REF: Major Spill VPR A-47 API # 30-00720197, Incident # NRM2005230899

Wapiti Operating Sampling Plan in reference to above stated incidents

Sampling Plan Map

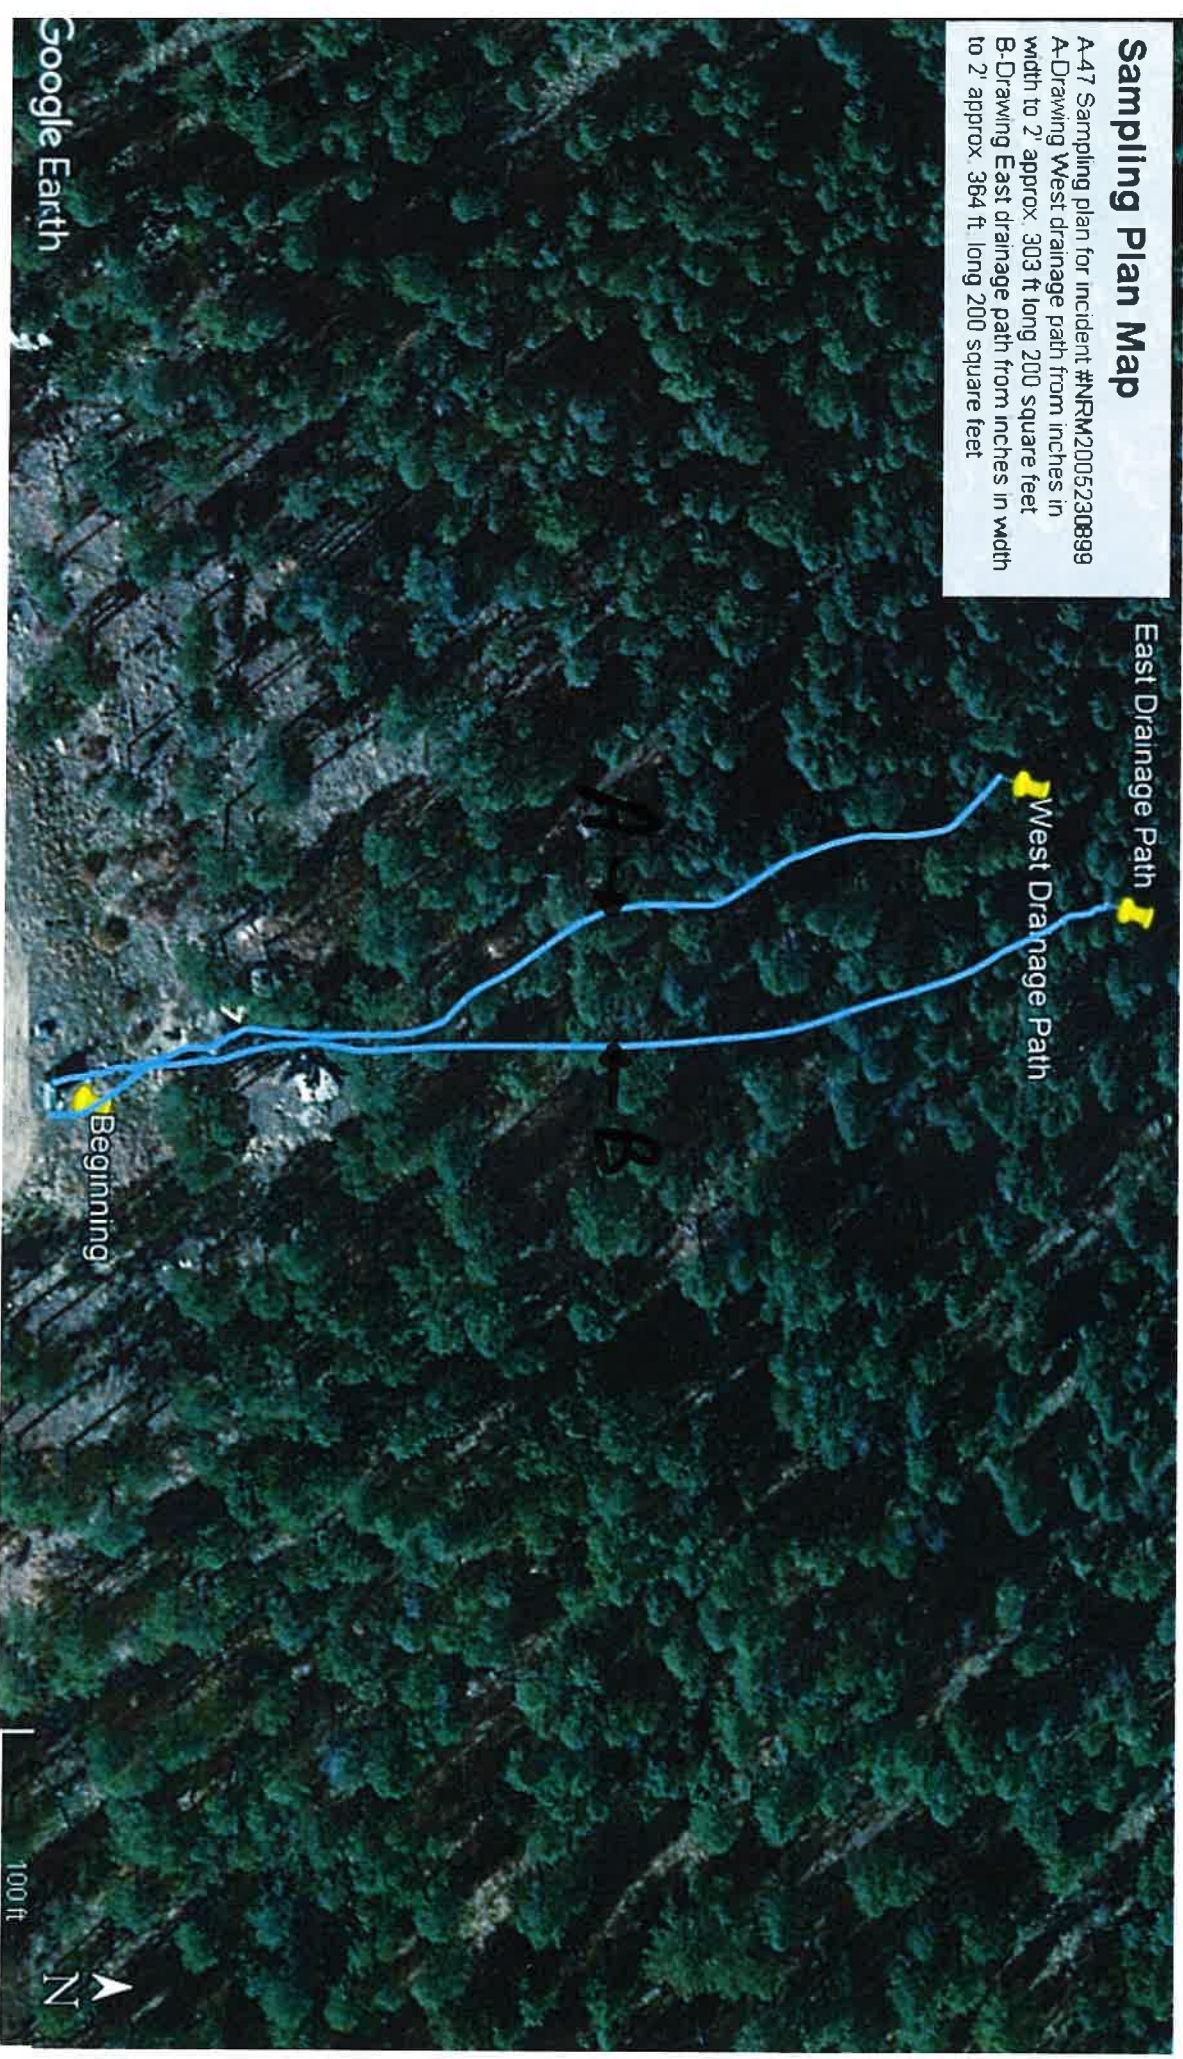
- One composite sample on each drainage path (Total of 2) consisting of five points with lengths varying from linear 60 to 70 ft. between points.
- The sampling will be conducted by hand (There is no access for heavy machinery, and the sample will be off of Wapiti's designated ROW)

A grab sample was collected at the source of the release on 3/2/20 and was submitted at the time of the release highlighting that remediation not believed to be required. The TPH came back out of the limits of Table 1. This additional testing should show that no remediation is needed.

OCD approves the following sampling plan.

For areas on the Wellpad Wapiti will collect a 5pt composite sample every 200 sqft.

For areas that are designated as "East/West drainages" Wapiti will collect a 5pt composite sample for every 200 linear Ft with aliquots every 40' ie 2 samples for West Draining and 2 samples for East drainage.

All samples will be analyzed for TPH,BTEX, and Chlorides
